Exhibit 4: Proposed Route
Prestonsburg - Thelma
Transmission Line
Rebuild Project

Kentucky Power Company
KPSC Case No. 2025-00346
Commission Staff's First Set of Data Requests
Dated January 14, 2026
Page 1 of 2

This legend provides a key for the symbols used in the map to represent different geological and proposed features. It includes:

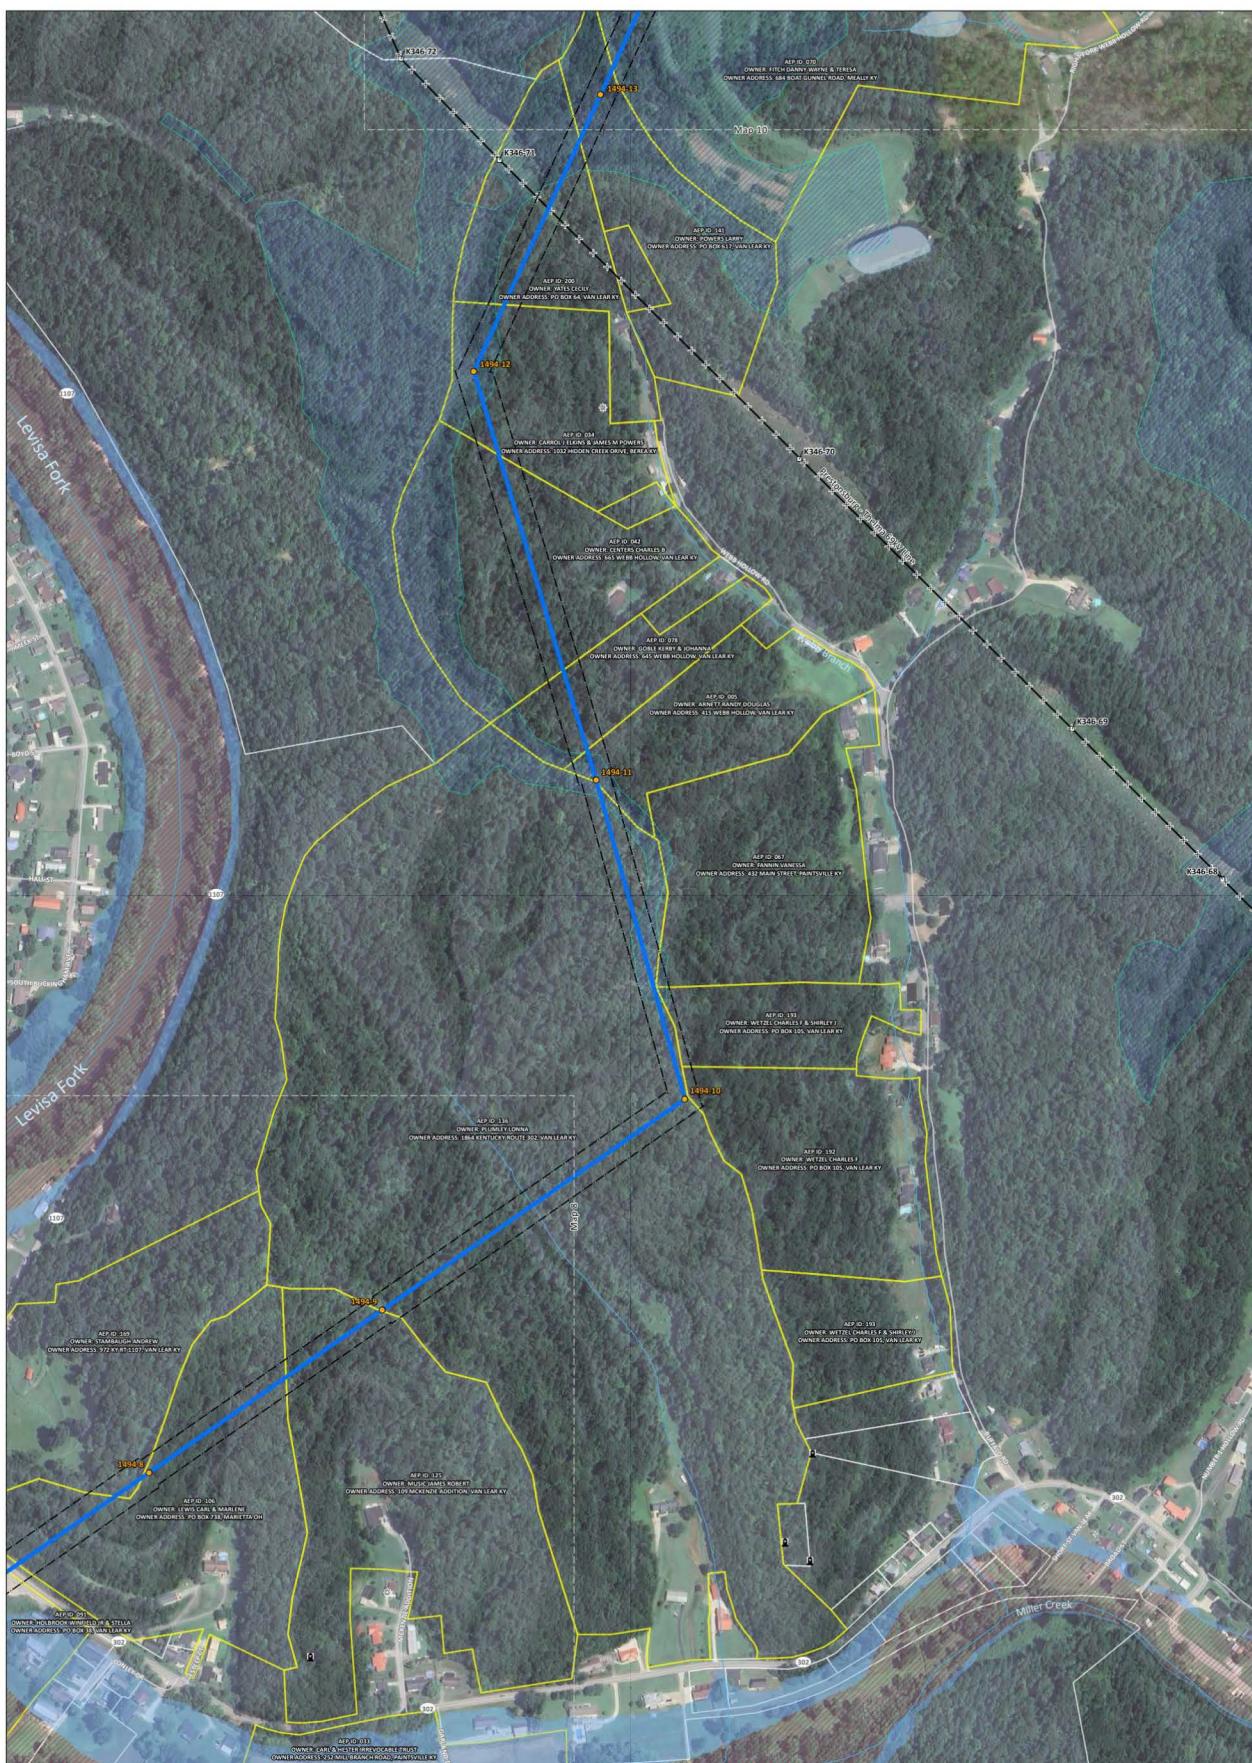
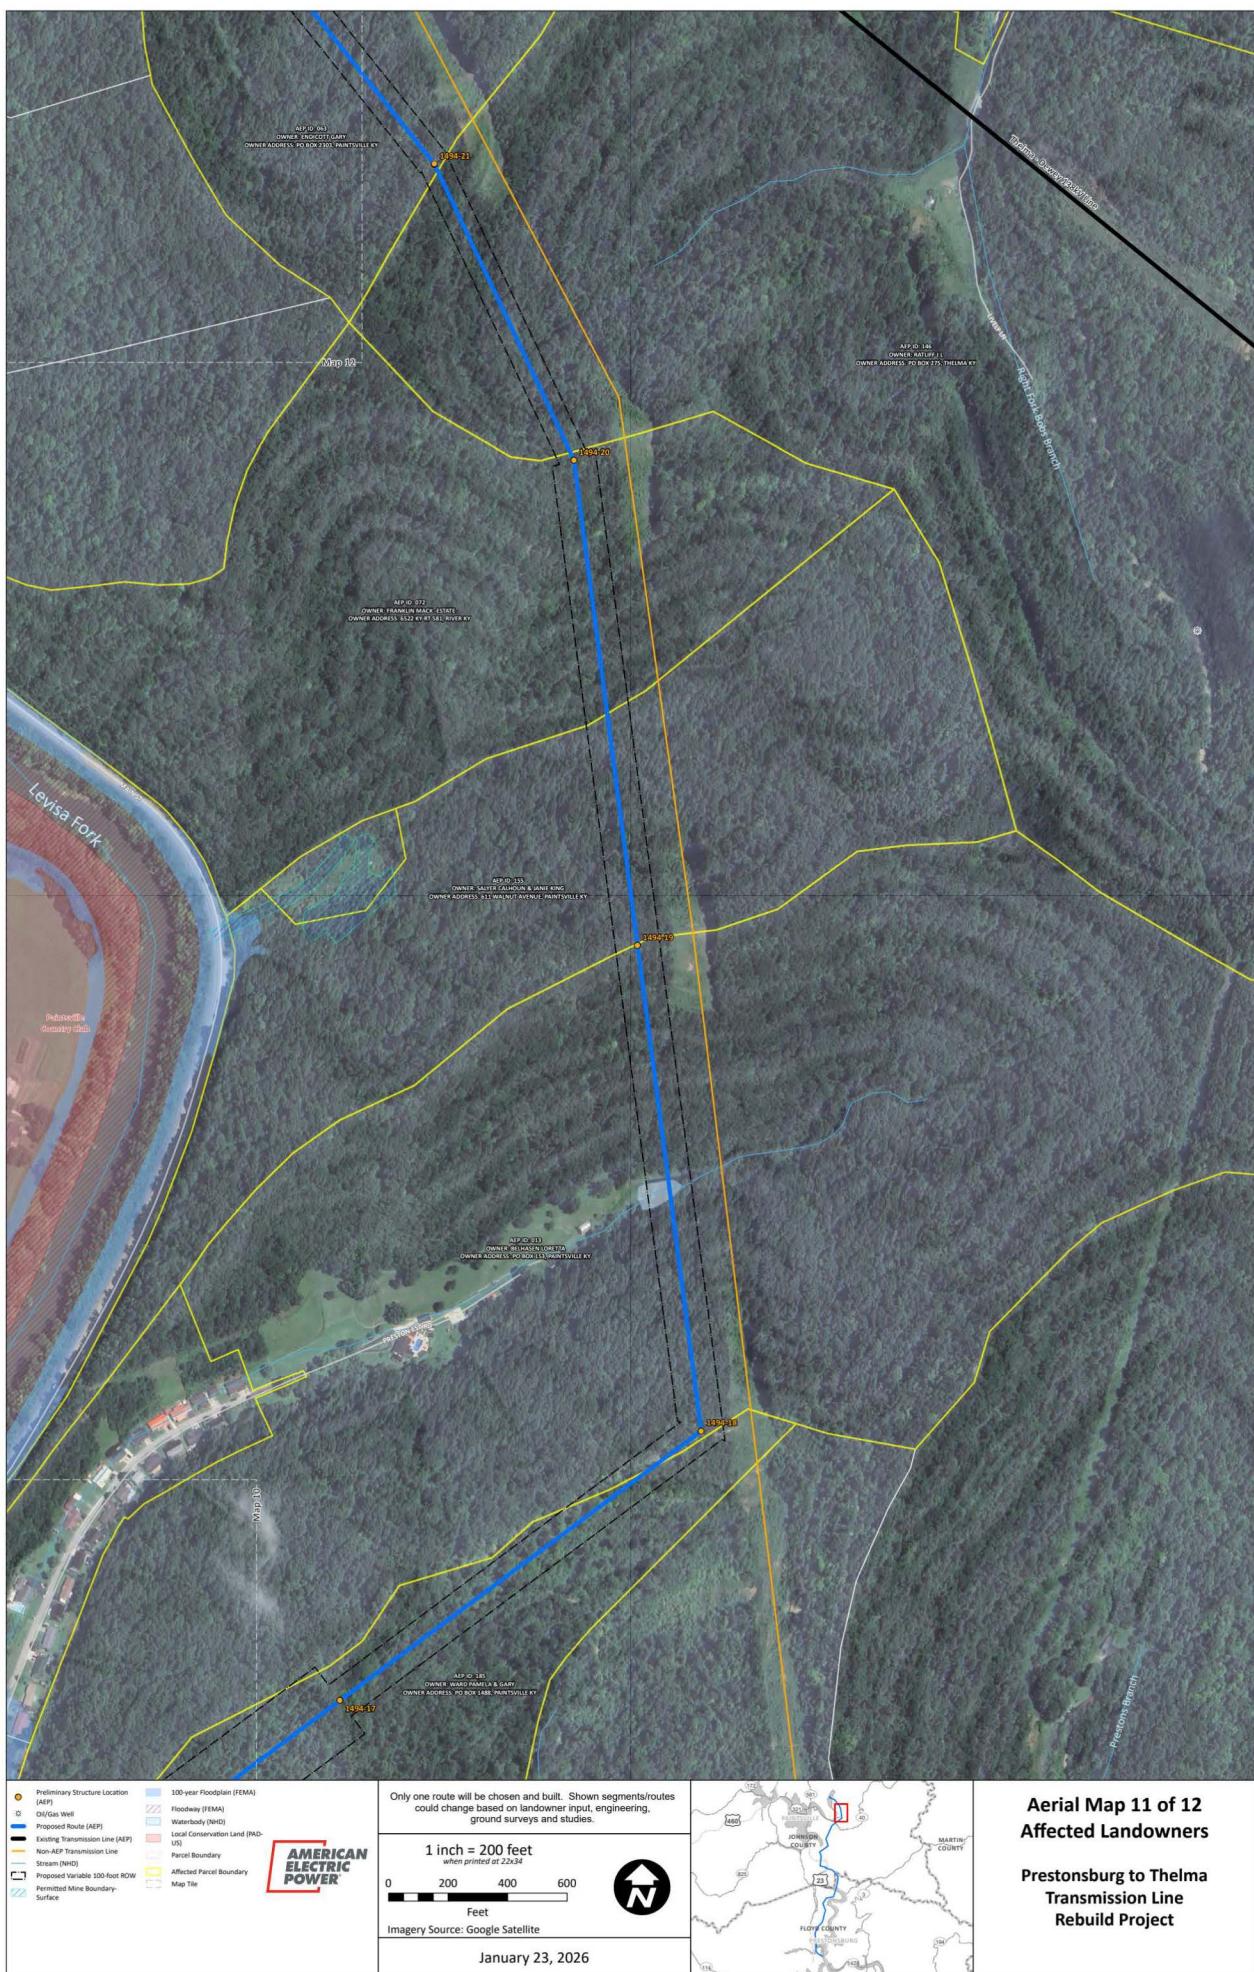
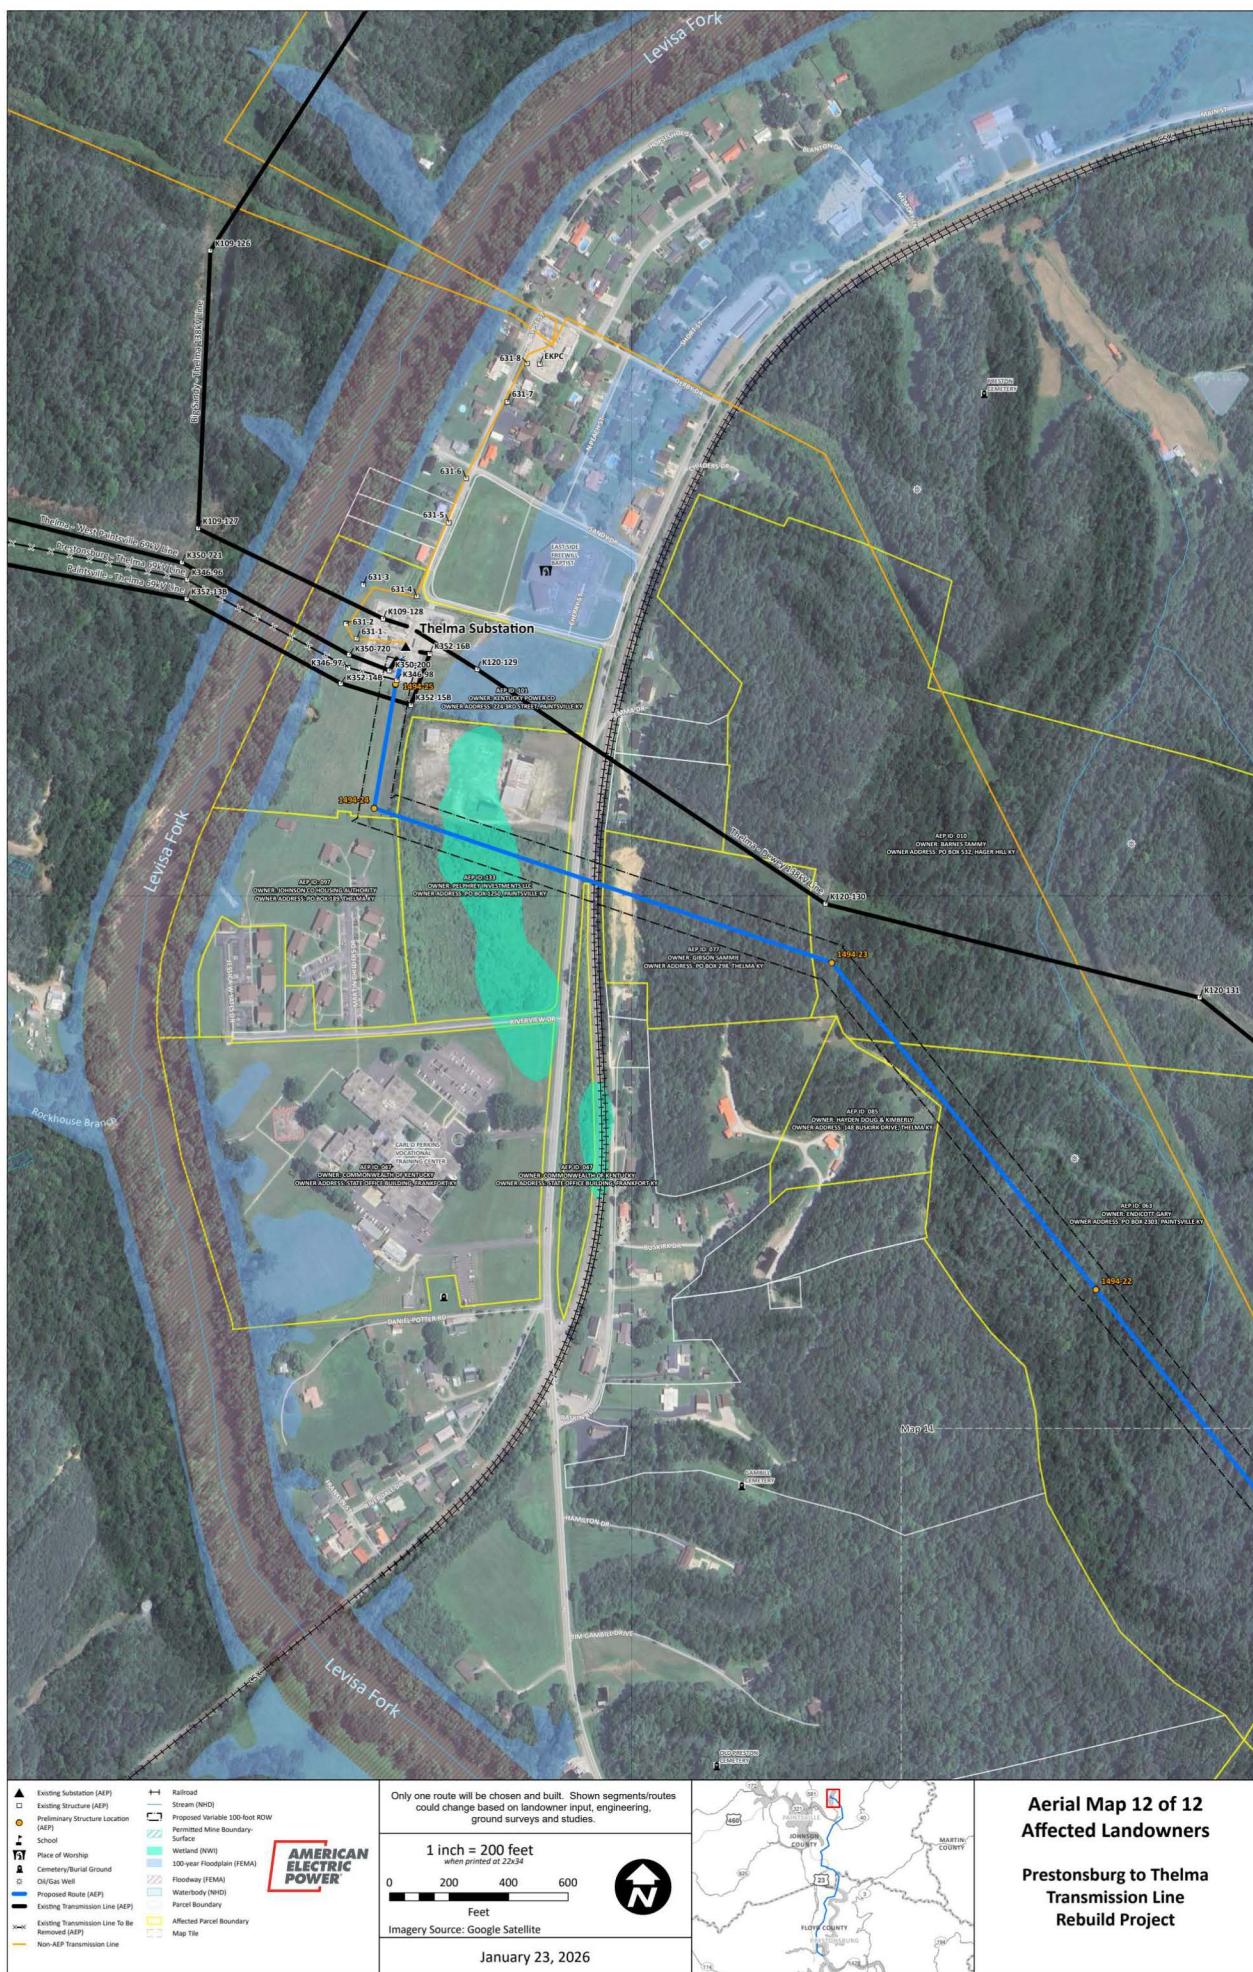
KPSC 1_33 Refer to the Application, pages 13–14.

- a. Provide an updated list of all Affected Landowners identified by the records of the property valuation administrator of Floyd and Johnson Counties, Kentucky.
- b. Provide a map showing the Affected Landowners' individual parcels of land in relation to the proposed Project route. Include data indicating the owner of each individual parcel of the map

- a. The Company used the PVA data and took additional efforts to update that list beyond the data provided. That list was updated in October, 2025, which was included in Exhibit 8 of the Application. The Company is not aware of any updates and believes the list provided to be the most up-to-date.
- b. Please see KPCO_R_KPSC_1_33_Attachment1, which includes a map depicting the landowners' individual parcels of land in relation to the proposed Project route and the owner of each individual parcel.
